AGENDA

HISTORIC PRESERVATION BOARD MEETING

**STAFF MEMORANDUM
HISTORIC PRESERVATION PROGRAM
PLANNING AND URBAN DEVELOPMENT**

TO: Chair Pollard and Members of the Historic Preservation Board
FROM: Rob Wiener, Historic Preservation Compliance Coordinator
DATE: October 28, 2022
RE: 1 Commercial Street – PUBLIC HEARING – Re-Approval of Expired Certificates of Appropriateness for Storefront Replacement and Upper Floor Rehab and Dormers
PROJECT ID: HPBR-002193-2022 (Plans Identical to HPBR-000687-2019, HPBR-000836-2019)
MEETING: November 2, 2022

Owner	
Prepared For:	
Consultant:	
Architect: ARCHETYPE architects 48 Union Wharf Portland, Maine 04101 (207) 772-6022 ARCHETYPE@ARCHETYPEPA.COM	
Project: 1 COMMERCIAL ST SHELL IMPROVEMENTS Portland, Maine	
Revisions:	
Date: 25 SEP 2019	Scale: As indicated
ELEVATIONS	
A2.01

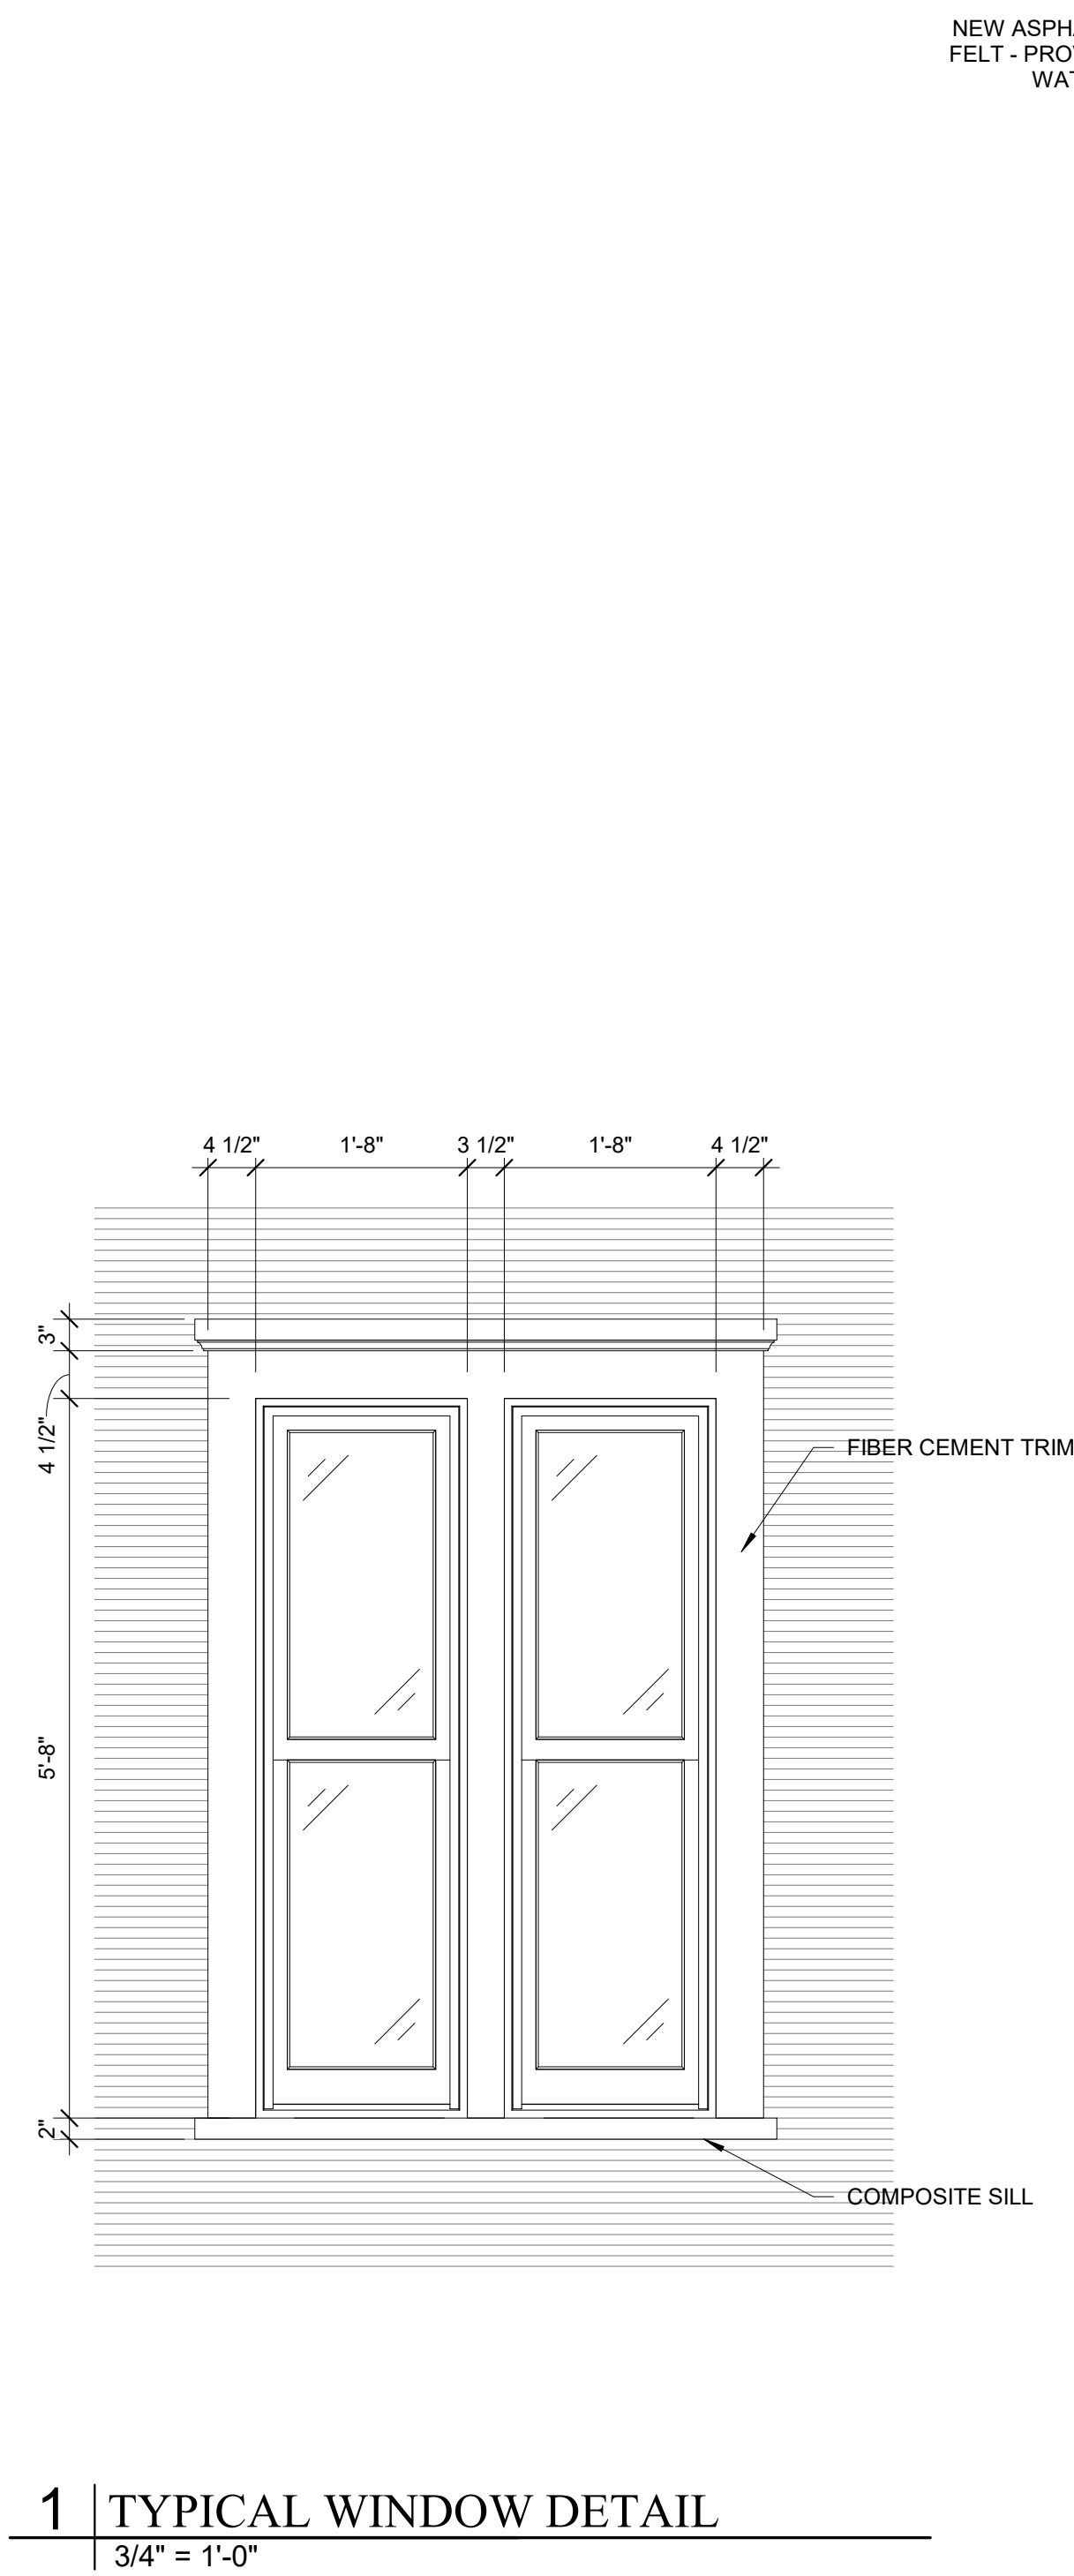
- The west dormer allows the primary roof to be dominant. The trim details shown on the details page (A5.00) – flat fascia with a shadow board – are not reflected on the elevations. In their past comments Board members encouraged the architect to employ enough detail to convey a simple historic style.
- Window type and layouts are regular, well-proportioned and similar in appearance to the predominant type in 1924.

Other questions remain for the Board, on whether desired features like the east inverted dormer, the balcony, and modern alternative materials can be judged to be compatible modern interventions.

- The new design for the east dormer bears much greater similarity to the west dormer than before, and with closed end walls, regularly spaced posts, finished surfaces on the interior, and a simple shed roof and trim detailing, it may soften the impact of the interruption in the roof. In appearance the new approach seems a quiet treatment for a modern cut into a prominent roof plane.
- Mr. Lloyd's new approach to the balconies on the south end (two shallow, light-weight metal balconies instead of one long one) is less obtrusive than before, but

- Finally, some Board members may be uncomfortable with the proposed use of fiber-cement clapboard siding to replace the existing wood clapboard. The general guideline adopted by the Board for replacement of wood siding would typically specify wood replacement clapboard; the Board might consider waiving the guideline with this project where fiber-cement is proposed for the upper stories of a downtown commercial building.
